# VALUE ENGINEERING REPORT

I-75 at 7 Locations from the Florida State Line to SR 122

NHS-0007-00(386), PI No 0007386

August 31, 2007

<b>IDEA No.:</b> A-2 (1)	<b>Sheet No.:</b> 1 of 4	<b>CREATIVE IDEA:</b> To Reduce Bridge Width (I-75 at CR 274)
-----------------------------	-----------------------------	---

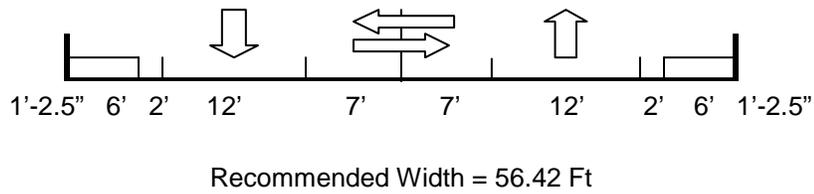
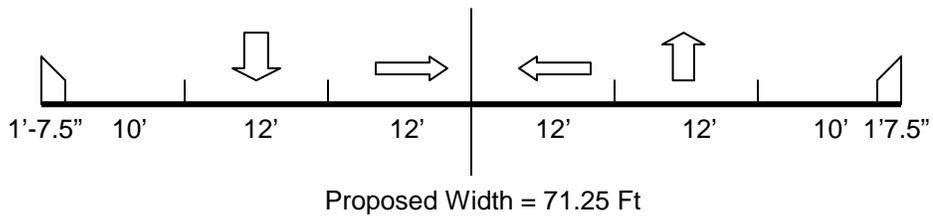
The traffic study report indicates the left turn volumes at this location do not require storage lengths requiring separate left turn lanes across the bridge. The traffic report indicates that approximately 150 feet of storage is necessary. The ramp intersections are sufficiently far apart to allow for a consolidated single left turn lane that would accommodate the projected left turns without the need for a second left turn lane. Converting the rural flush shoulders concept to a sidewalk and parapet typical section is consistent with the typical sections used on the bridges at SR 376, SR 31, and SR 133.

This concept has the potential to save significant project cost, reduce construction time, improve constructability, reduce the amount of project ROW, and lessen the project's impact on the community.

<b>IDEA No.:</b> A-2 (4)	<b>Sheet No.:</b> 1 of 4	<b>CREATIVE IDEA:</b> To Reduce Bridge Width (I-75 at SR 31)
-----------------------------	-----------------------------	--

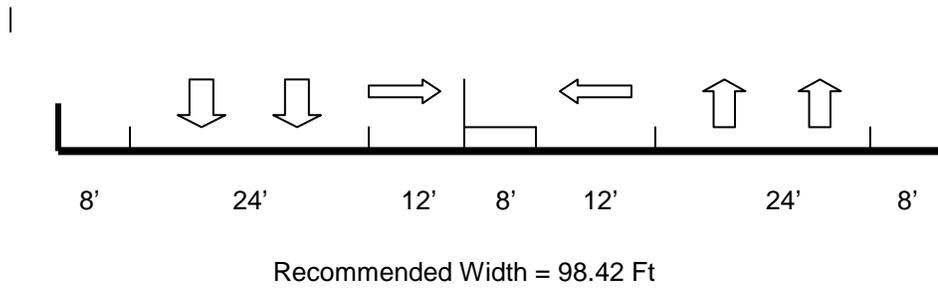
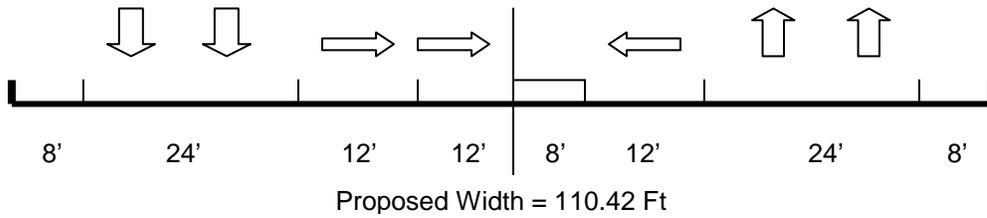
The traffic study report indicates the left turn volumes at this location do not require storage lengths requiring 3 separate left turn lanes across the bridge. The traffic report indicates that approximately 150 feet of storage is necessary for eastbound traffic and a double 150-foot left storage area for westbound traffic. The ramp intersections are sufficiently far apart to allow for a consolidated left turn lane plus a second left turn lane for westbound traffic if deemed necessary.

Removing this lane will reduce the bridge width and make the bridge easier to construct. This concept has the potential to save significant project cost, reduce construction time, improve constructability, reduce the amount of project ROW, and lessen the project's impact on the community.

<b>IDEA No.:</b> A-2 (5)	<b>Sheet No.:</b> 1 of 4	<b>CREATIVE IDEA:</b> To Reduce Bridge Width (I-75 at SR 133)
-----------------------------	-----------------------------	---

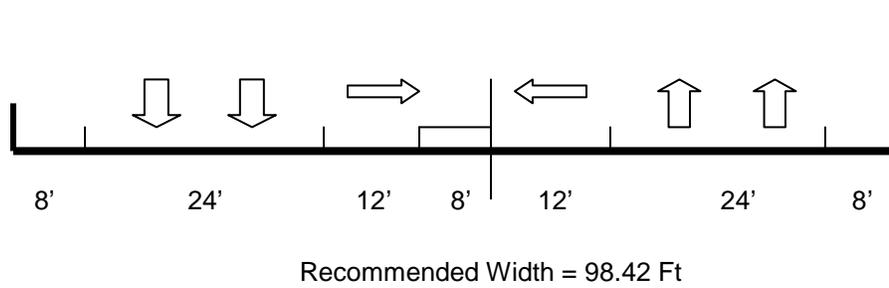
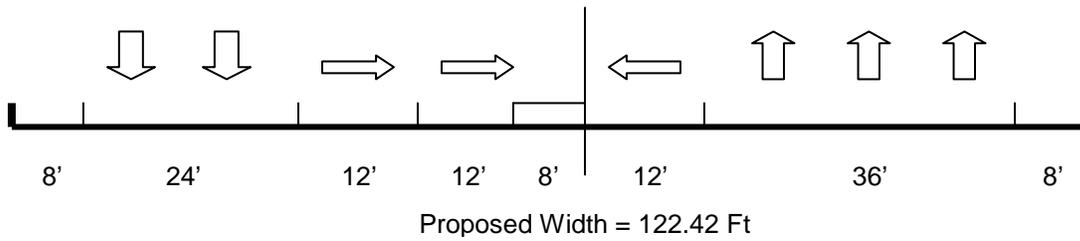
The traffic study report indicates the left turn volumes at this location do not require storage lengths requiring three separate left turn lanes across the bridge. The traffic report indicates that approximately 150 feet of storage is necessary for eastbound traffic and a double 250-foot left storage area for westbound traffic. The ramp intersections are sufficiently far apart to allow for a consolidated left turn lane plus a second left turn lane for westbound traffic if deemed necessary. It also does not appear to be necessary to carry a third eastbound through lane across the bridge since only two eastbound lanes exist on the west side of the structure.

Removing these lanes will reduce the bridge width and make the bridge easier to construct. It will also reduce the negative impacts of a wider roadway section within the commercial area on the east side of I-75. This concept has the potential to save significant project cost, reduce construction time, improve constructability, reduce the amount of project ROW, and lessen the project's impact on the community.

<b>IDEA No.:</b> A-2, B-2	<b>Sheet No.:</b> 1 of 4	<b>CREATIVE IDEA:</b> To Reduce Bridge Width & Minimize Side Road Reconstruction at SR 122
------------------------------	-----------------------------	---

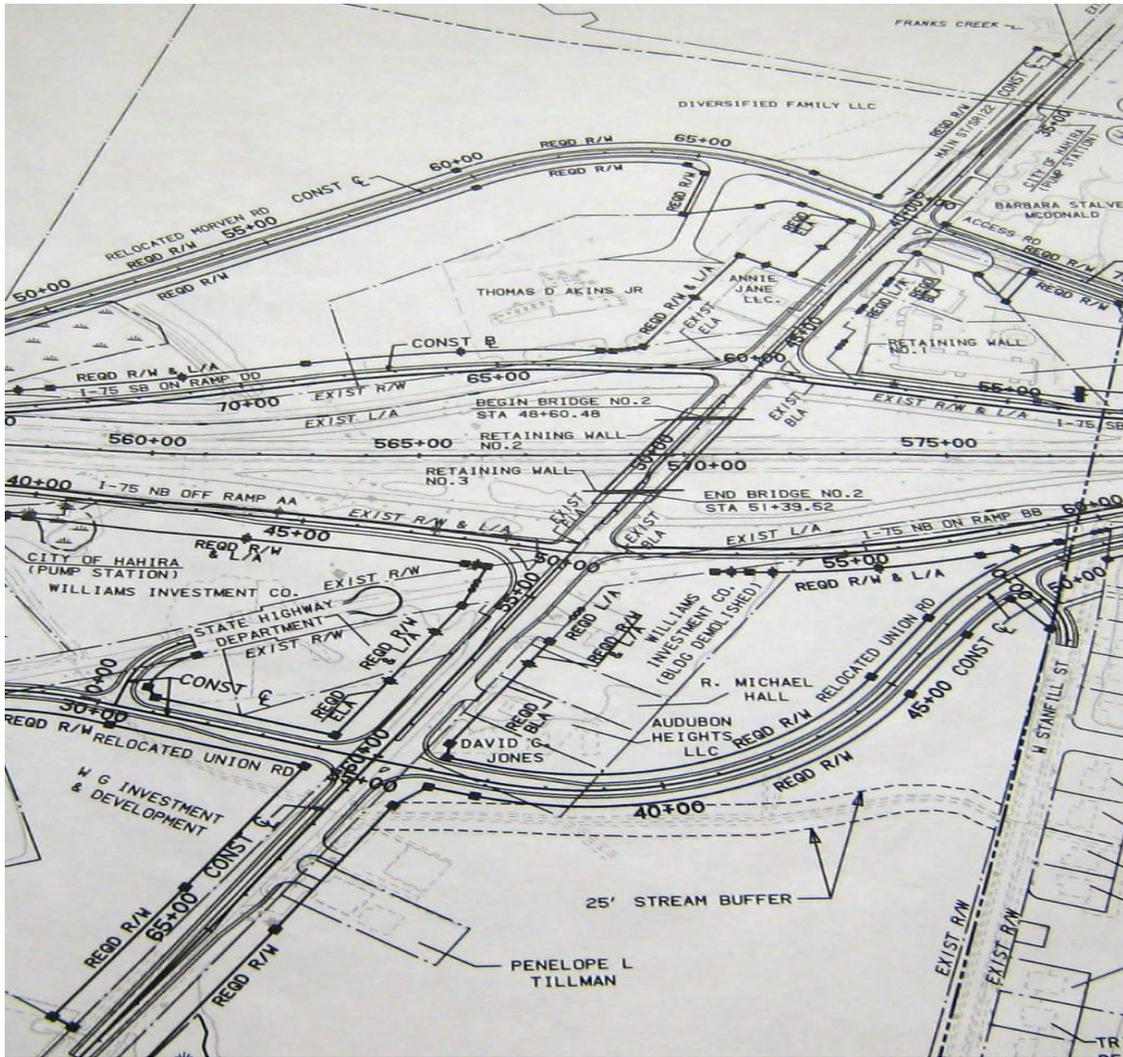
The traffic study report indicates that SR 122 will have less than 5,000 ADT in the design year build-out which does not warrant an expansion to five lanes. In addition, future traffic is so light that traffic signals are not warranted for the ramp intersections. The ramp intersections are sufficiently far apart to allow for a consolidated left turn lane (to accommodate 150 feet of storage in both directions).

Removing these lanes will reduce the cross road and bridge typical section. This concept has the potential to save significant project cost, improve constructability, reduce construction time, and lessen the project's impact on the community.

**CR 274, SR 376, Loch Laurel Rd, SR 31 & SR 133 Bridges over I-75**

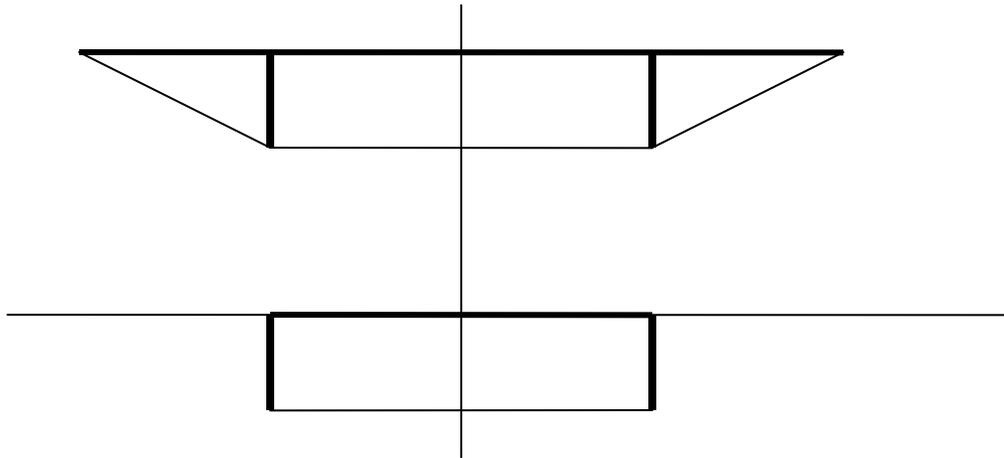
The proposed design for the 5 Interchange cross road bridges (CR 274, SR 376, Loch Laurel Road, SR 31 and SR 133) crossing I-75 show four-span structures with short end spans and 2:1 end slopes.

Typical 2-Span Bridge with MSE Walls with Pile End Bents

ITEM N<sup>o</sup>: A-4 (6)  
 CLIENT: GDOT  
 Sheet: 2 of 4

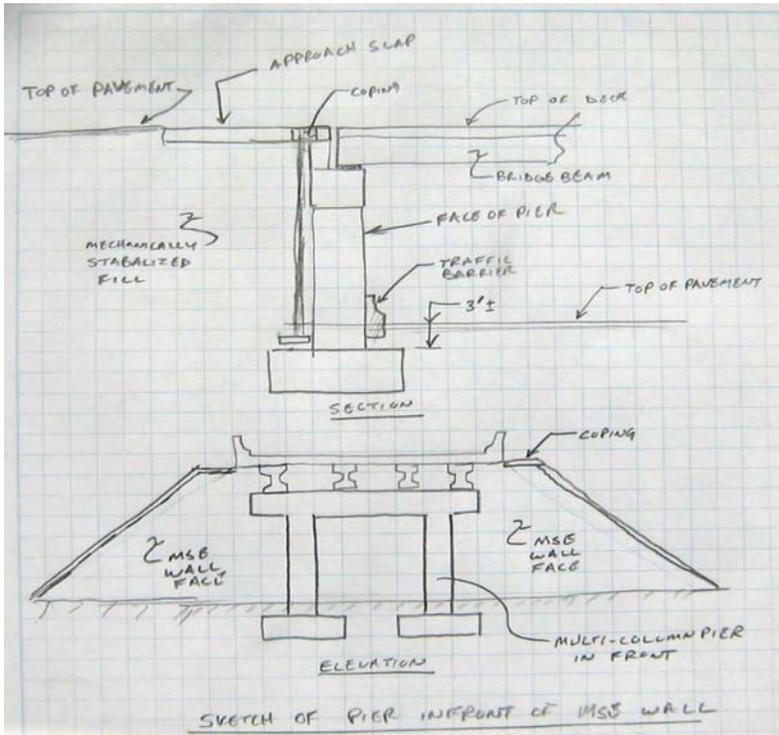
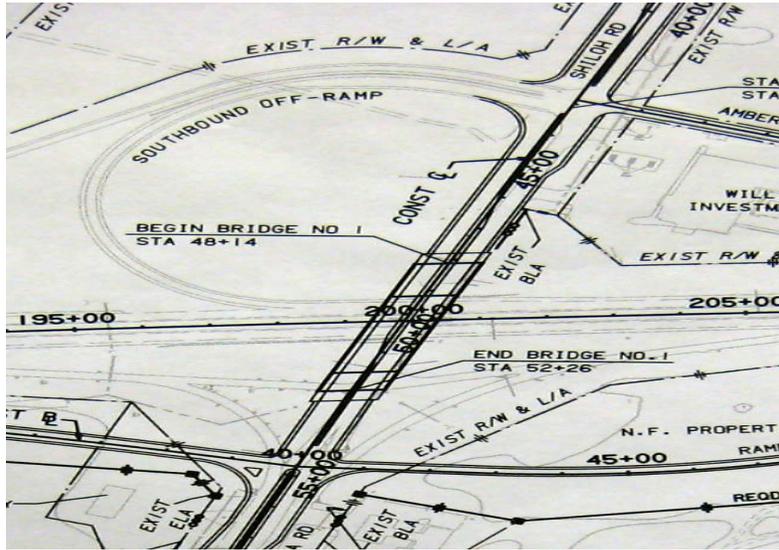
<b>IDEA No.:</b> A-4 (6)	<b>Sheet No.:</b> 1 of 4	<b>CREATIVE IDEA:</b> To Use a 2-Span Bridge with MSE Wall at the Abutments (I-75 at SR 7)
-----------------------------	-----------------------------	---

<b>IDEA No.:</b> B-2	<b>Sheet No.:</b> 1 of 3	<b>CREATIVE IDEA:</b> Minimize Side Road Reconstruction
-------------------------	-----------------------------	--

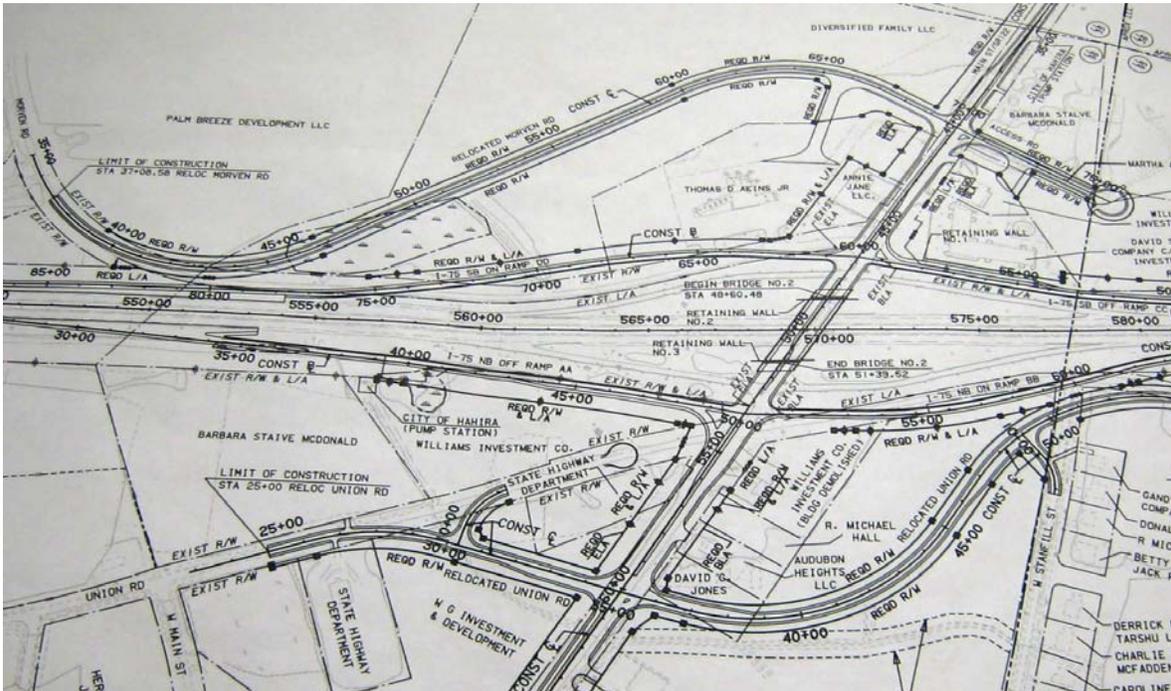
It is recommended that the shoulder width be reduced to 6 feet (2-foot paved).

The recommended reduced shoulder width complies with the GDOT Design Manual when local roads are being designed for speeds of less than 50 mph. The reduced shoulder width would be adequate for these roads due to the extremely light projected traffic and low design speeds of these roads. Reducing the shoulder width would result in a potential cost savings to the project. It could also reduce the time needed to construct these roads.

<b>IDEA No.:</b> B-5	<b>Sheet No.:</b> 1 of 4	<b>CREATIVE IDEA:</b> Eliminate Additional Pavement in Ramp Tapers for Future 4 <sup>th</sup> Lane
-------------------------	-----------------------------	---

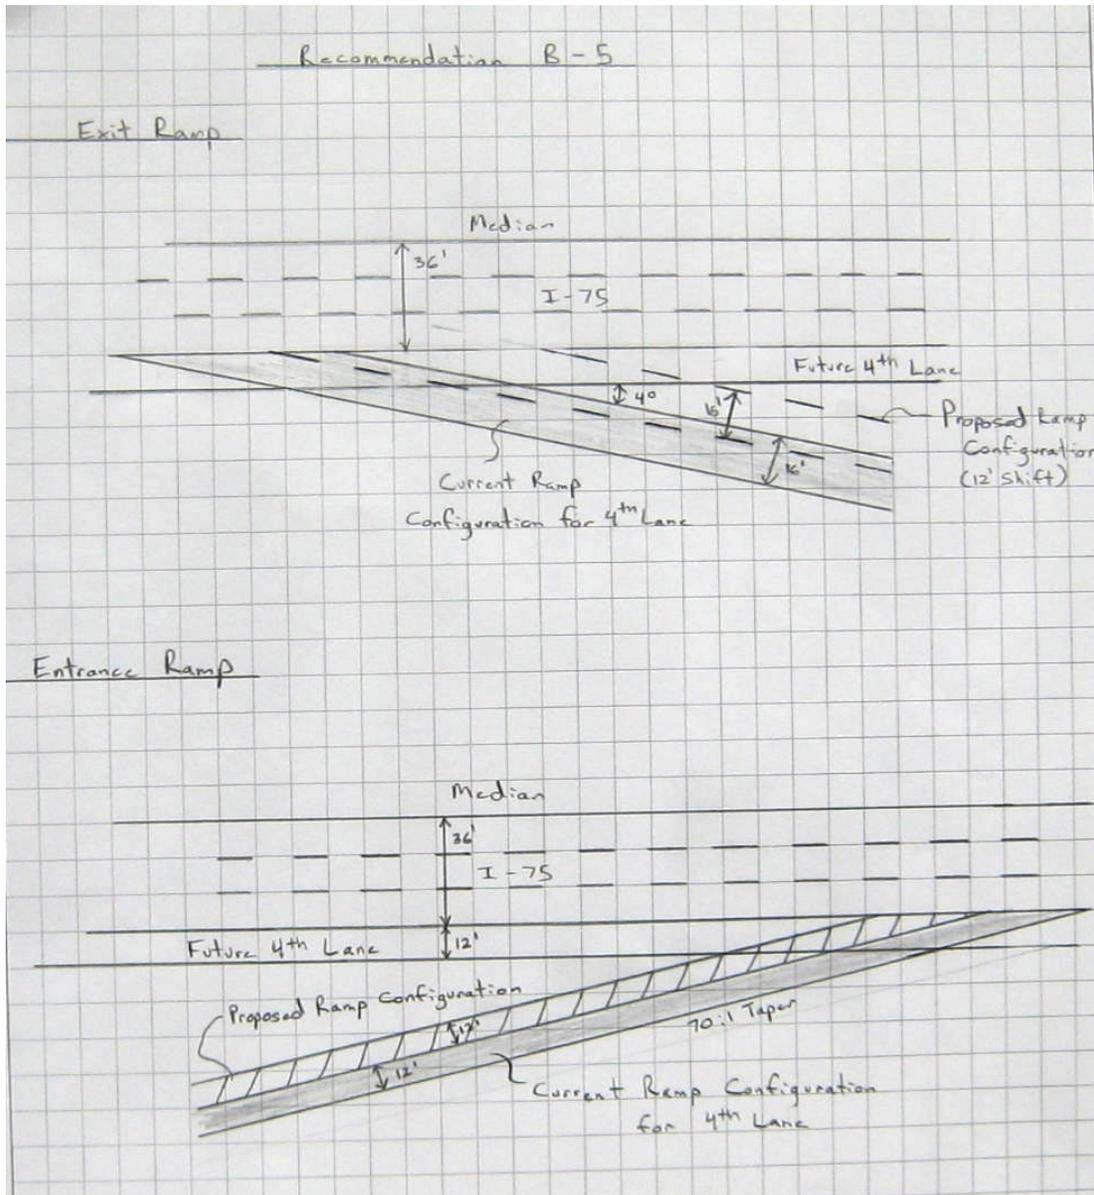
The current design proposes to extend exit and entrance ramp tapers to accommodate possible future widening of I-75 from 6 to 8 lanes for the Interchange ramps at CR 274, SR 376, SR 31 and SR 133. Additional asphalt pavement is provided to tie into a future 4<sup>th</sup> lane in each direction. Additional striping is added to align the current ramp tapers to tie into the existing outside travel lane.

It is recommended that the entrance and exit ramp tapers be redesigned to tie into the existing 6-lane section and eliminate additional pavement for possible future widening of the Interchange ramps at CR 274, SR 376, SR 31 and SR 133. The ramp alignments will need to be adjusted to account for the shift in the ramp tapers.

The capacity analysis of I-75 indicates that the through movement on the Interstate will operate at a level of service 'C' in the design year (2032), which is acceptable for projects in rural areas. It is anticipated that the future widening of I-75 to 8 lanes will not occur for more than 20 years after the completion of construction for these projects. If the additional pavement is constructed during the current project, it is likely that it will need to be reconstructed before the construction of the future widening to 8 lanes.

<b>IDEA No.:</b> A-5	<b>Sheet No.:</b> 1 of 2	<b>CREATIVE IDEA: Design Suggestion</b> To Identify / Define the Ultimate Typical Roadway Section for I-75
-------------------------	-----------------------------	---

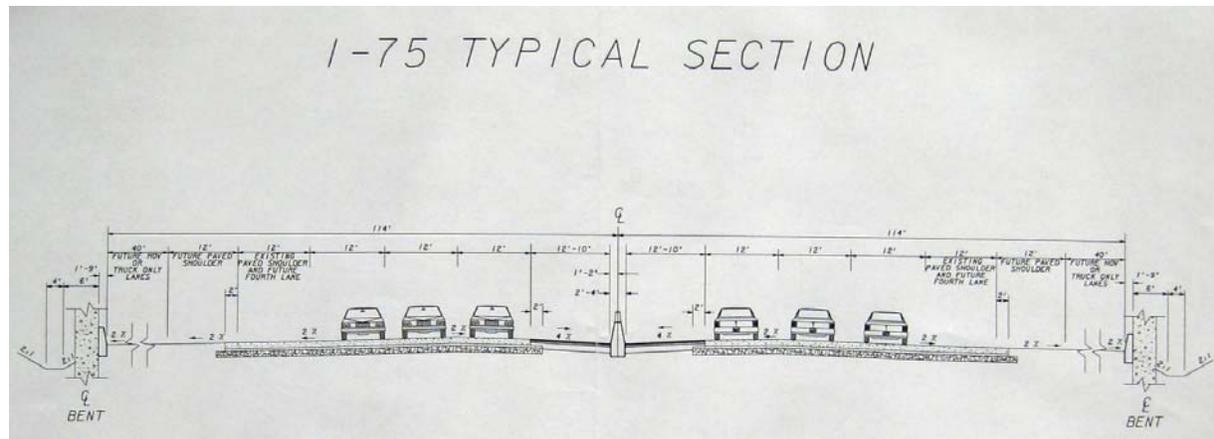
The bridges at Sites 1-5 are being designed for a different typical section than the bridges at Sites 6 & 7. Throughout the study, the team received information showing different standards for the ultimate roadway section for I-75. The various standards have led to different criteria being used to determine the new bridge lengths needed to cross I-75. The different standards (various median widths, number of lanes, and clear zone dimensions) have resulted in non-uniform bridge lengths at the 7 locations under design and also brings into question whether the 2 Interchanges that are not being redesigned in this corridor will provide adequate clearance for the ultimate I-75 section.

ITEM N<sup>o</sup>: A-15  
CLIENT: GDOT  
Sheet: 2 of 2

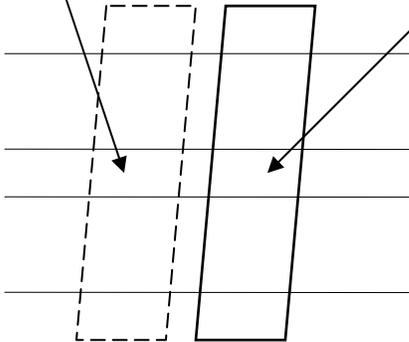
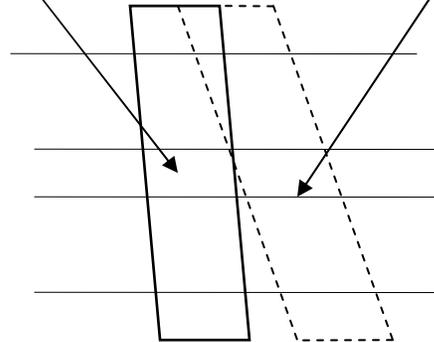
Reconstructing new bridges on the same location as the existing bridges poses considerable constructability and traffic control issues. While no construction staging plans have been developed, the staging schemes required will be expensive and problematic. Shifting the centerline alignments a small amount to the north will provide space to construct part / all of the new bridges away from the existing structures. At both locations there may be some additional ROW impacts associated with shifting the centerlines, however, planned whole ROW takes in the NE and NW quadrants (SR 376) and NW quadrant (SR 31) should minimize the impacts and provide room for the centerline shift. Shifting the centerlines would also allow for a reduction in the skew angle of the bridges resulting in shorter spans and improved constructability.

Recommended  
Centerline Shift

<b>IDEA No.:</b> C-3	<b>Sheet No.:</b> 1 of 2	<b>CREATIVE IDEA: Design Suggestion</b> Consider Local Road Closures and Possible Detours for constructing the New Bridges at SR 376 & Loch Laurel Rd.
-------------------------	-----------------------------	---

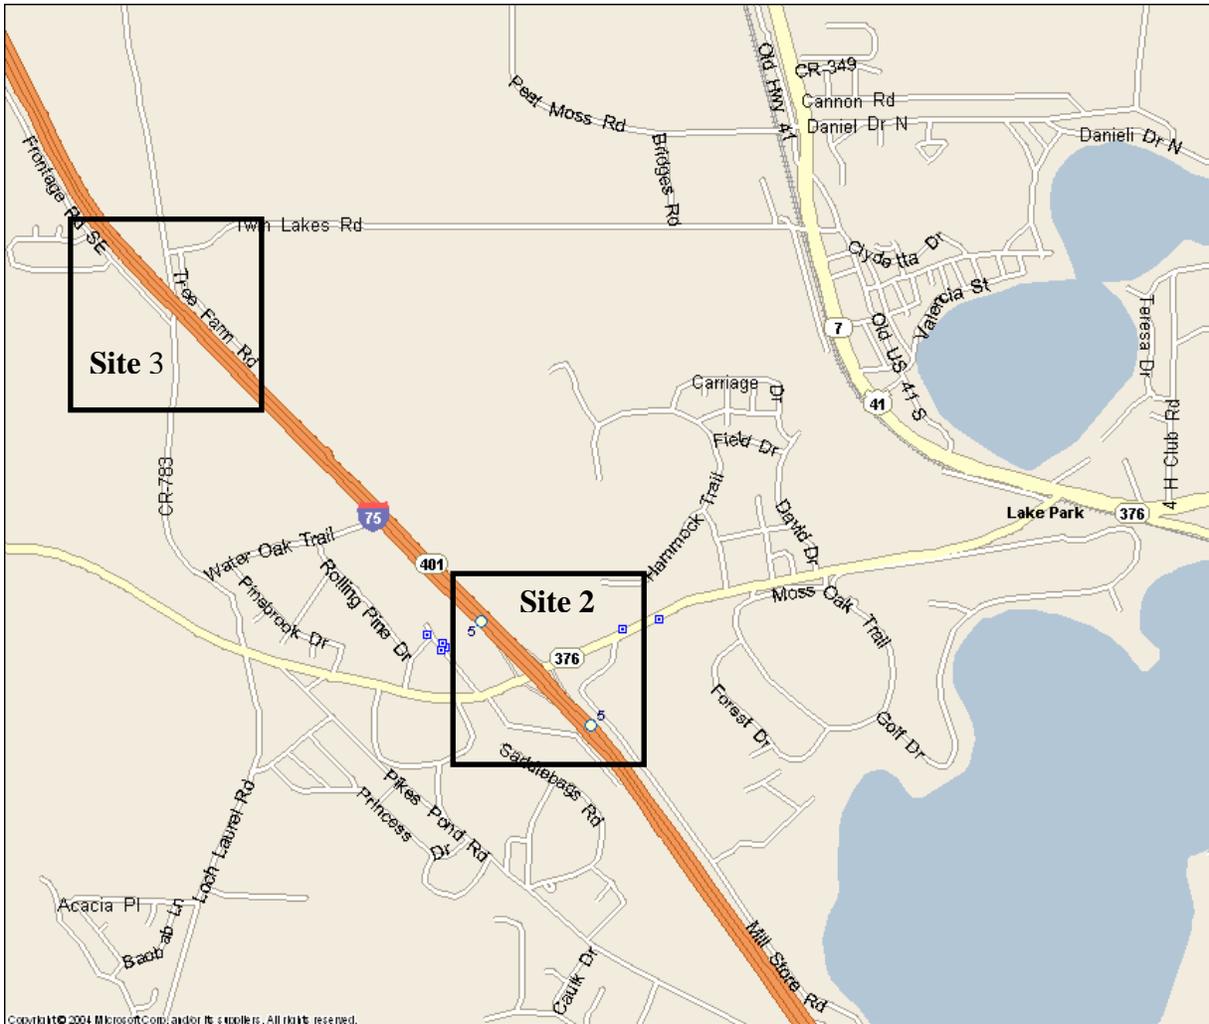
**Proposed Change:** It is suggested that consideration be given to alternately closing the crossroads at SR 376 and Loch Laurel Road and detouring local traffic around the site during construction.

**Justification:** A reasonable circular detour route exists between SR 376 and Loch Laurel Road that would allow for closing one local crossroad at a time to simplify and expedite construction at the closed site. The detour route would follow SR 376 east to US-41, north on US-41 to Twin Lakes Road, west on Twin Lakes Road to CR 783, South on CR 783 to SR 376, and east on SR 376.

Closing local traffic at an entire site would allow the contractor to occupy the entire site and perform the bridge demolition and new construction, (bridge replacement, ramp construction, local crossroad construction) in a much more streamlined and efficient manner. This concept would result in a much faster and safer construction project.

It will also be important to review the condition of the existing roads to be used for the detour and calculate the anticipated detoured traffic's impact on these roads.
